# RECORD OF DISCUSSION

## Planning & Zoning Commission

**1. Dublin Village Redevelopment at 6800 Federated Blvd and 6711-6815 Dublin Center Drive, 22-050INF, Informal Review**

Proposal: Informal Review and feedback for the development of attached townhomes and multiple-family residential with structured parking. The 8.17-acre site is zoned Bridge Street District, Sawmill Center Neighborhood.

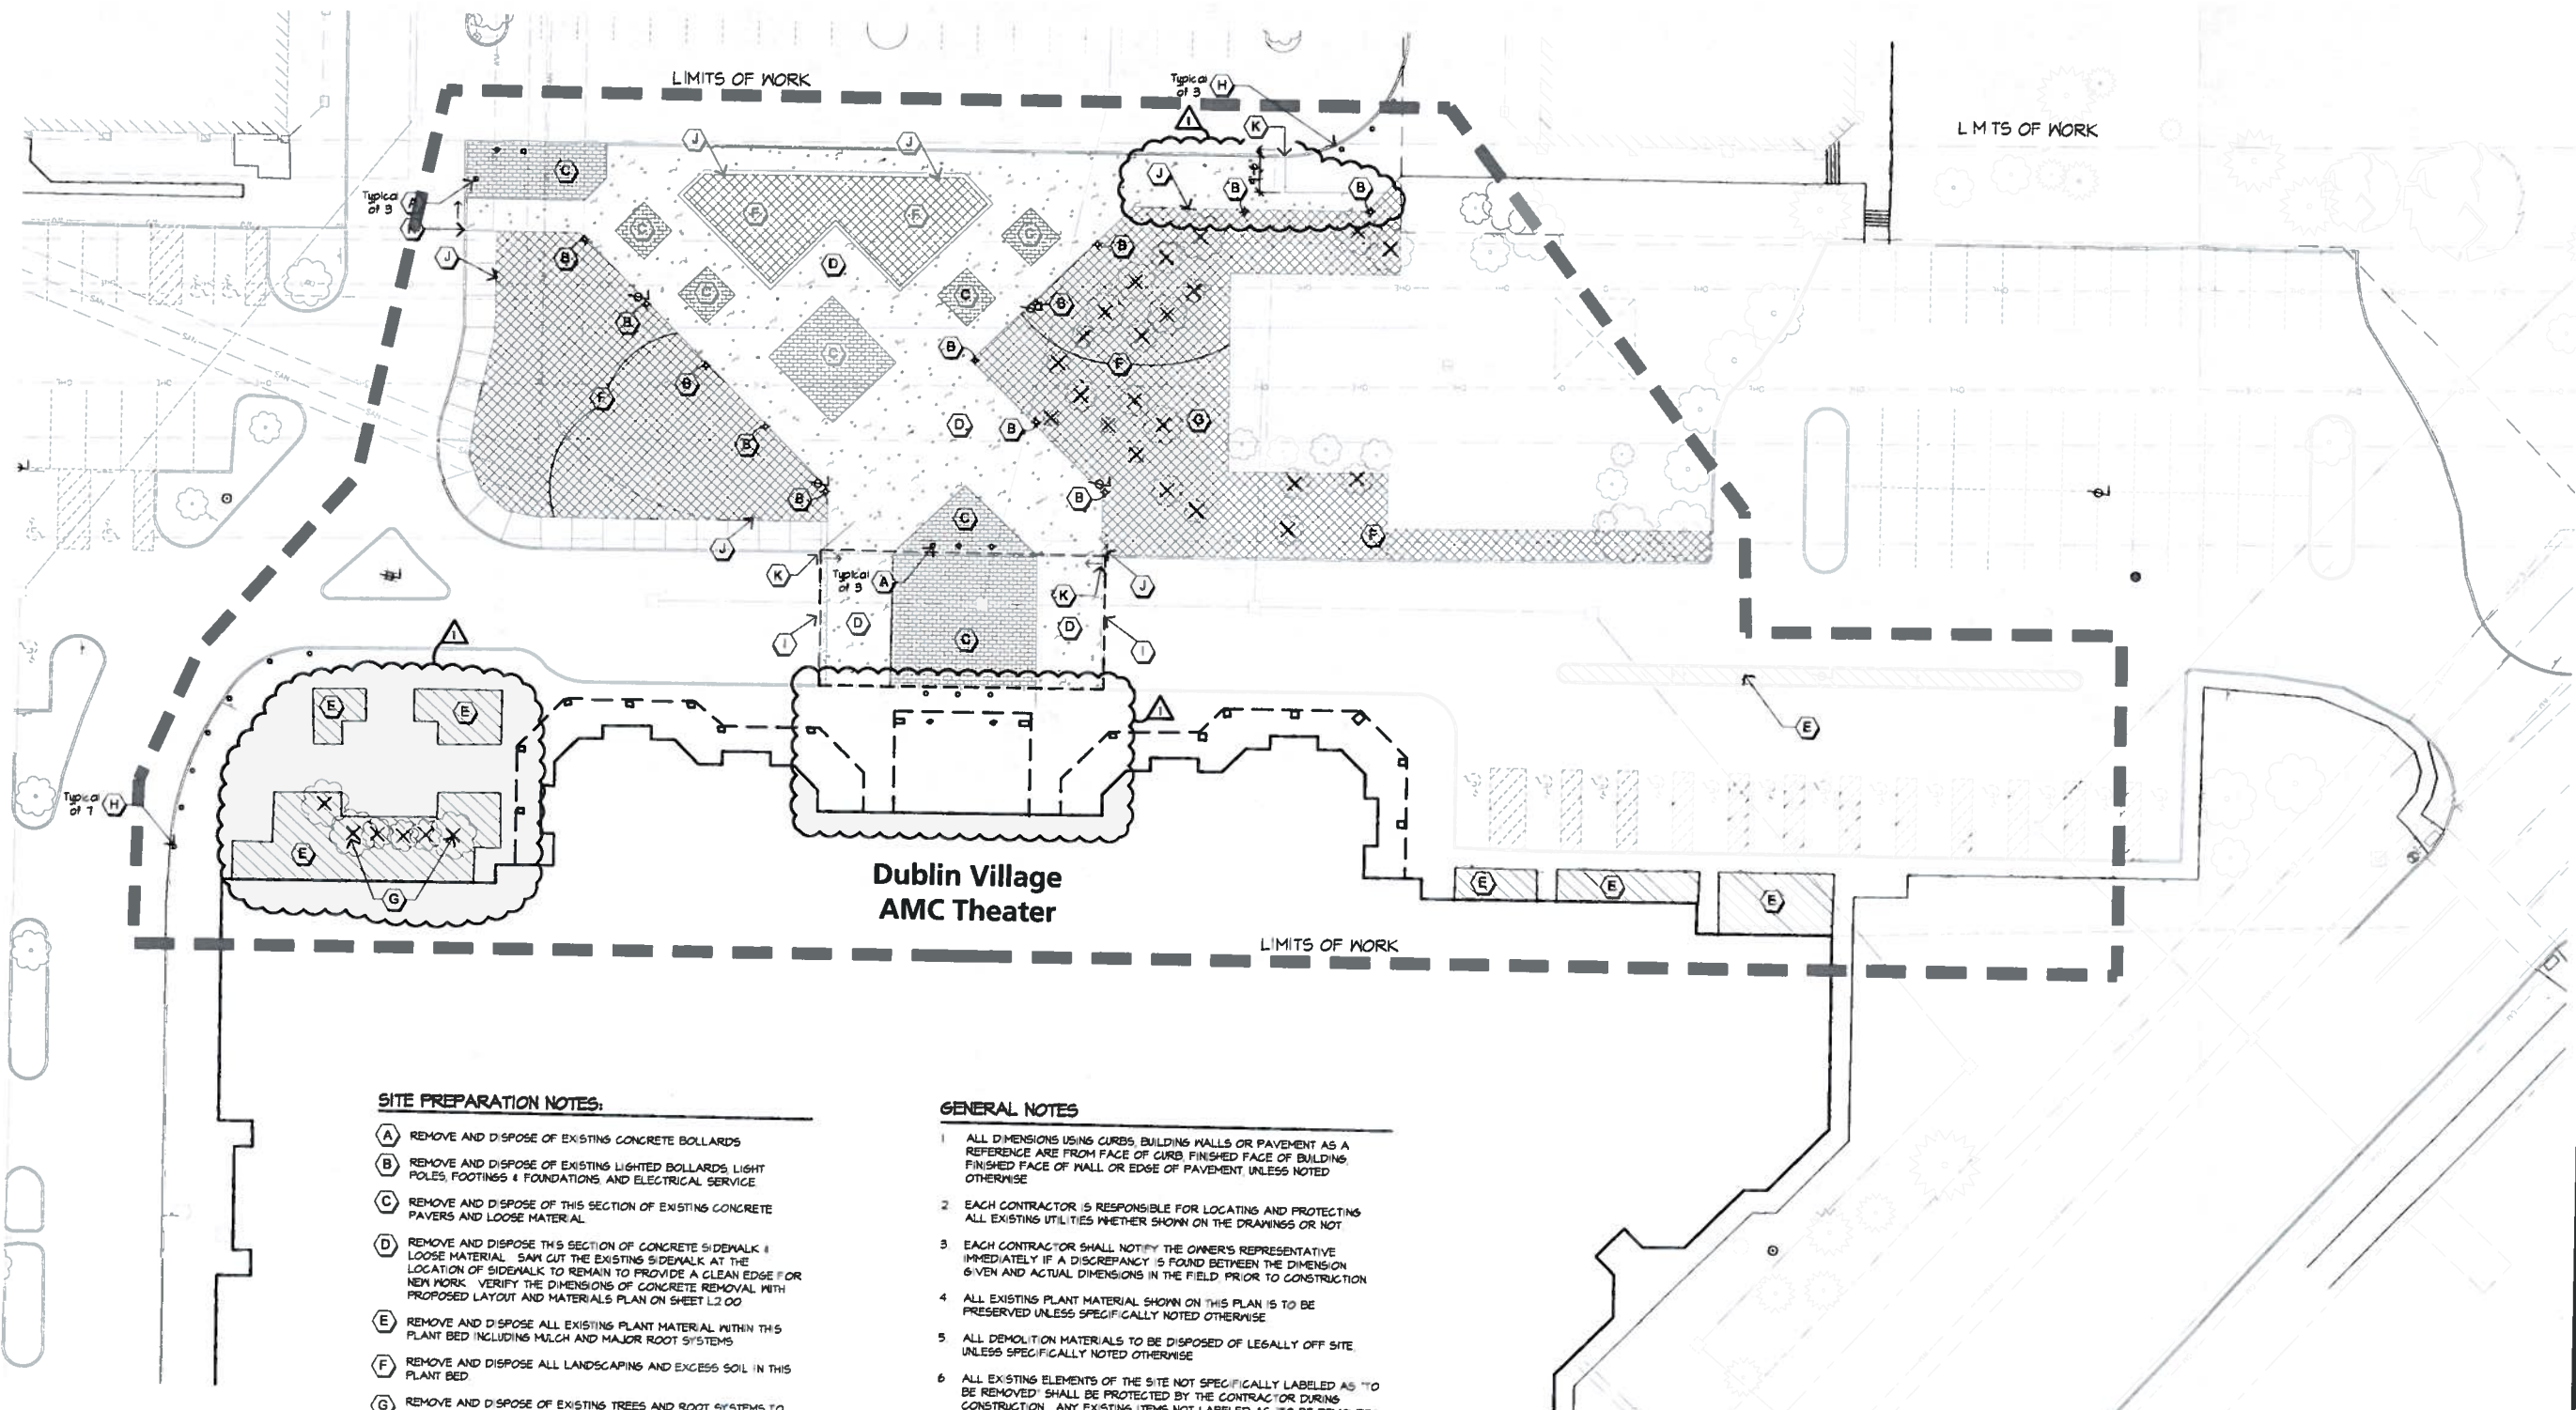
Planning recommends the applicant provide documentation of approval from AEP regarding the proposed tree selection and site modifications to ensure compliance with AEP requirements for overhead electric lines. Any landscape substitutions required as a result of AEP's review would be subject to approval by Planning as a Minor Modification.

Additionally, Planning is concerned with the overall plant material selection. Given the improvements have been completed, no substitution is required at this time; however, should replacements be sought in the future they would be subject to approval by Planning. Planning recommends that specifications for furnishings be submitted to Planning for review and approval prior to installation.

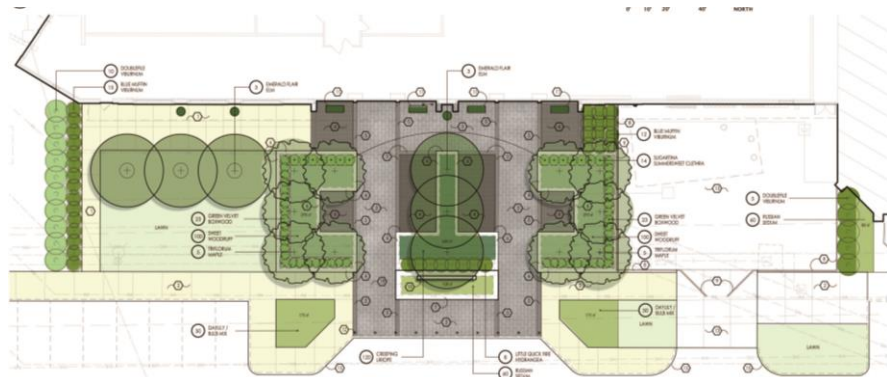
The applicant is proposing to replace 154 linear feet of an existing EIFS façade with a new storefront system. The improvement from a blank façade to a storefront façade brings the building closer to conformance with the BSD Code. The storefront is proposed to be an aluminum system in a 'Night Hawk Gray' finish with clear glazing windows between the frames. The storefront system will create nine openings where up to two tenant spaces may be included. The coping surrounding the storefront system will be prefinished metal in a 'Champagne' finish. In areas where the new storefront system is not proposed, the applicant is proposing a Nichiha horizontal panel material in a 'Bark' finish to serve as a backdrop for the new tenant spaces. Nichiha, a cementitious material, is a permitted secondary material within the Bridge Street District. The applicant should work with Staff to verify that the cementitious material does not exceed 20% of the entire west façade of the building. The remainder of the façade within the scope of this project will be painted EIFS in an 'Urbane Bronze' finish. Finally, the applicant is proposing a thin set 'Buffstone' watertable below the installation of the horizontal panels. The applicant will be painting the remainder of the existing EIFS, doors, and utilities not within the scope of the storefront improvements in a 'Pussywillow' (Gray) color. New light fixtures are proposed to accent the building and be compatible with the overall shopping center. The applicant should work with Staff to finalize the lighting selection, subject to Staff approval, prior to building permit submittal.
